WOLLONGONG CITY COUNCIL

# Traffic Committee Minutes of Meeting

9 May 2023

Item 4.1 – HORSLEY, Shone Avenue – Stage 2 & 3, page 1 of 2

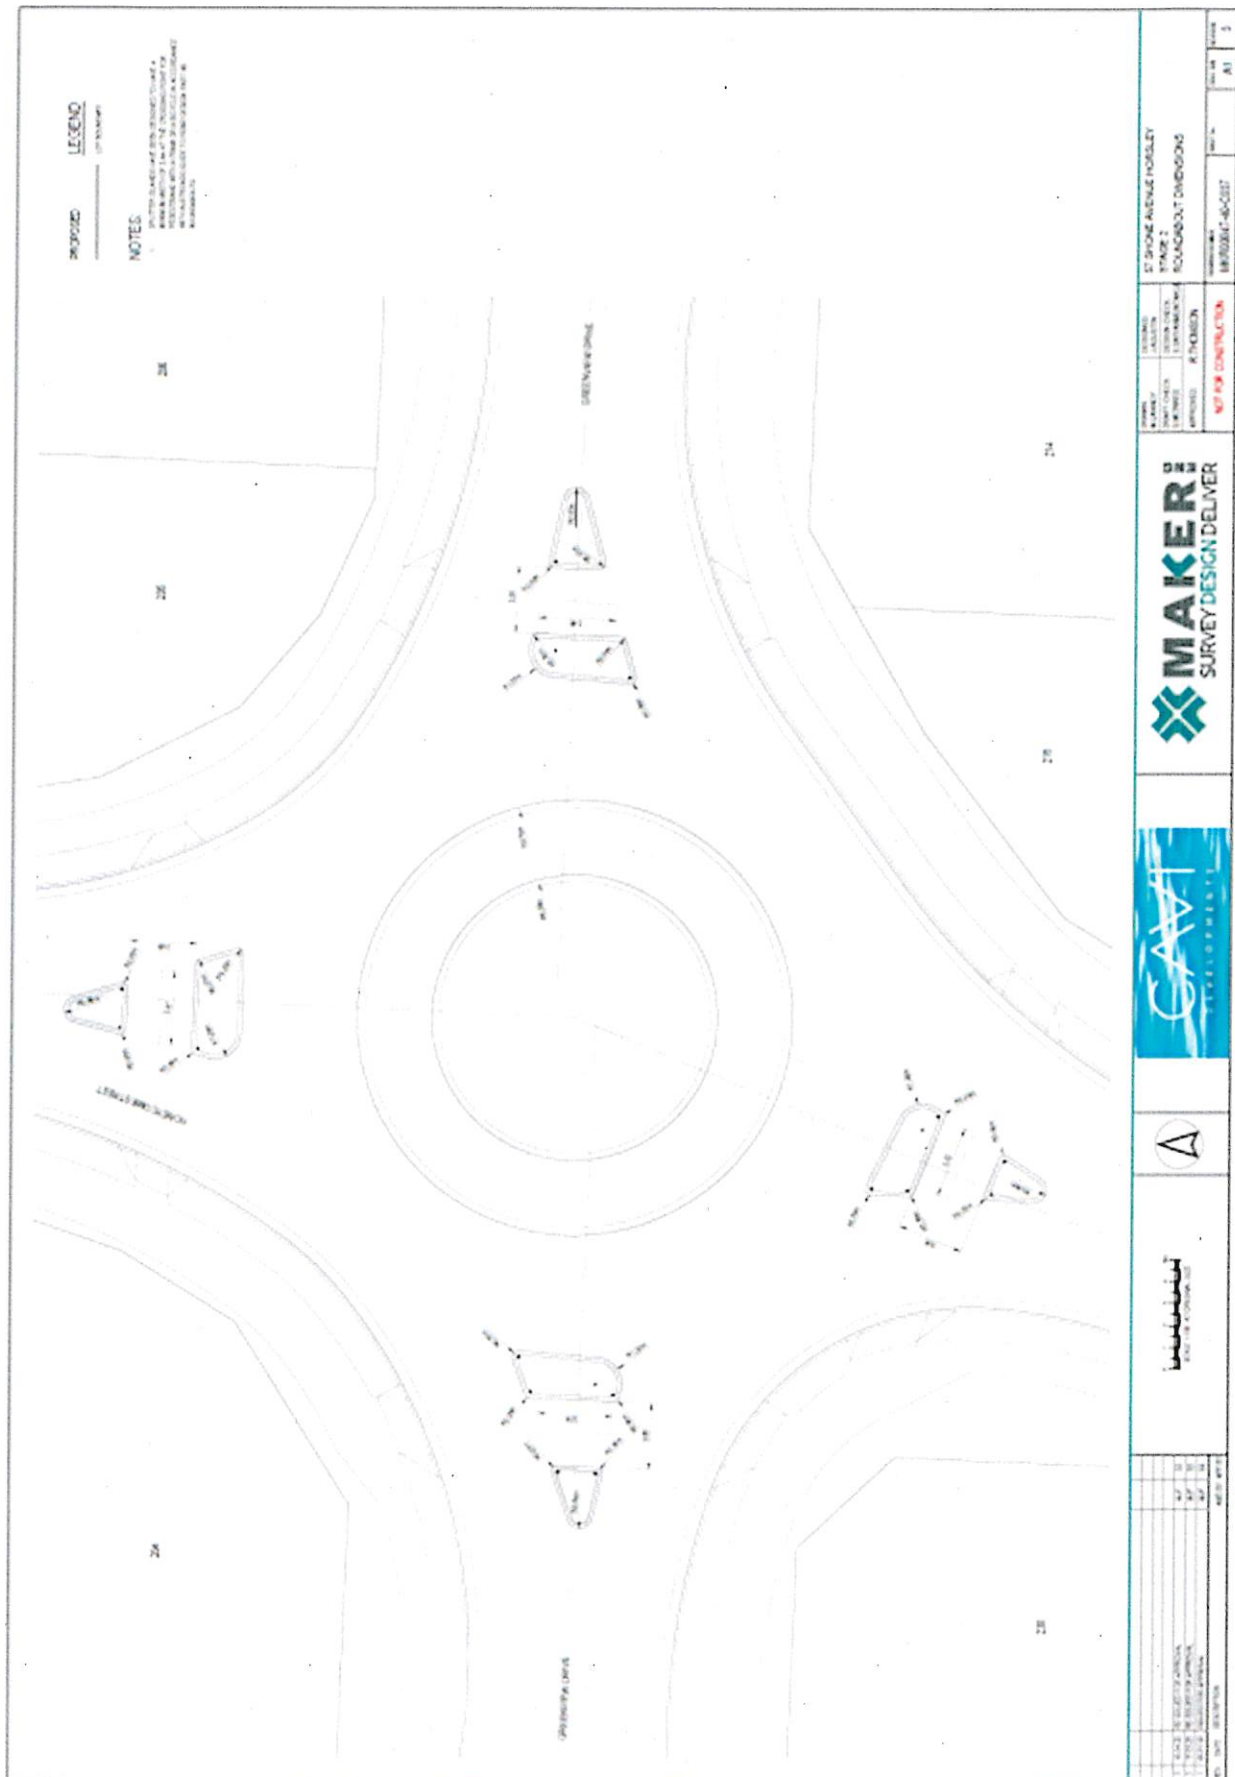
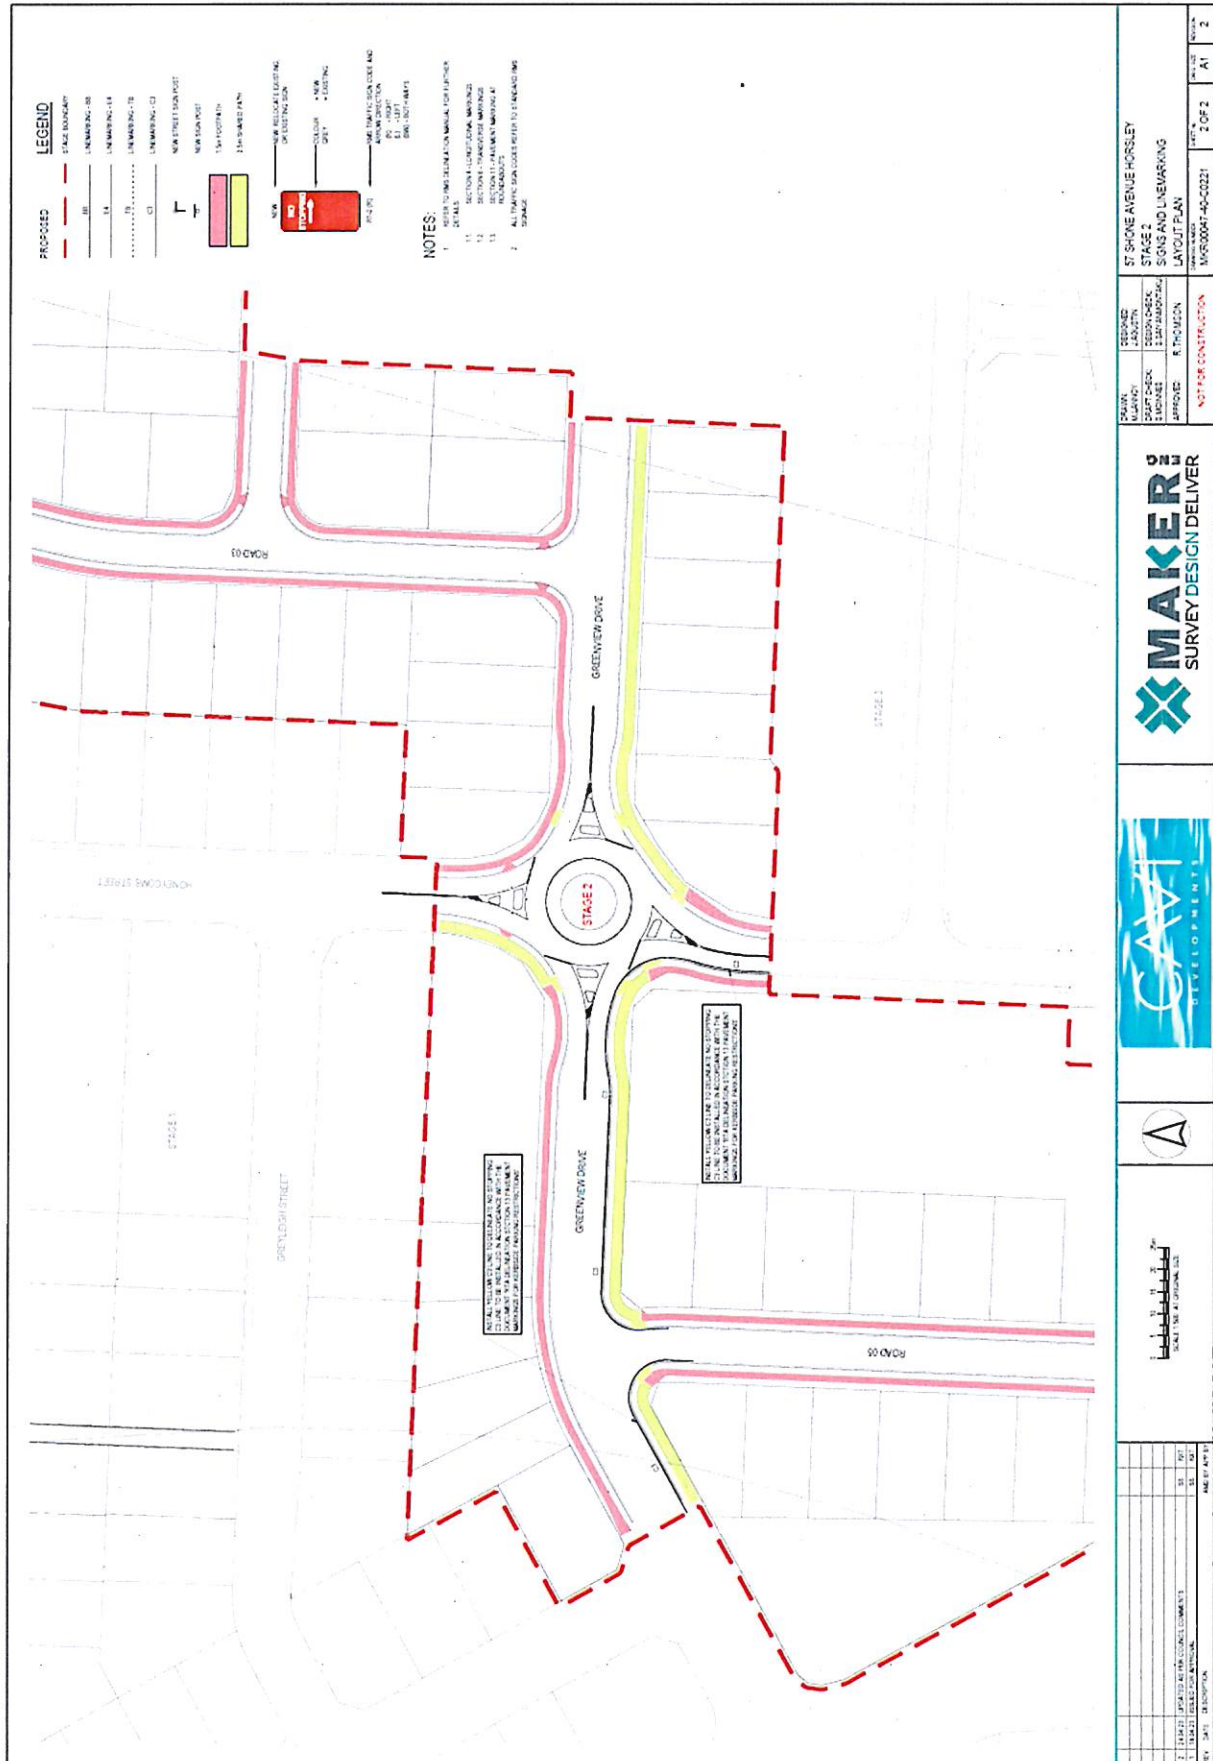
1. Design to be reviewed to ensure parking arrangements allows sufficient sight distance at the intersection of Greenview Drive and Road 03.

2. Design to be reviewed – splitter islands are sized to accommodate cyclist storage.

An intersection sight distance assessment in accordance with Austroads was completed. Based on the assessment, No Stopping linemarking (C3) has been provided. The developer has been requested to consider kerb build outs in the future if possible, however this will not part of this proposal as the road layout is fixed.

The splitter islands have been sized to accommodate pedestrians with prams or bicycles with a minimum width of 2.4m at the crossing point in accordance with Austroads Guide to Road Design Part 4B: Roundabouts also satisfy AS1742 Part 10: Pedestrian Control and Protection with a minimum width of 2m.

Signs and Lines Layout Plan, Job no. MRK00047-40, Drawing no. C220, Revision 1, by Maker Eng, dated 24/04/2023 and Job no. MKR00047-50, Drawing No. C220, Revision 1, by Maker Eng, dated 24/04/2023 be approved.
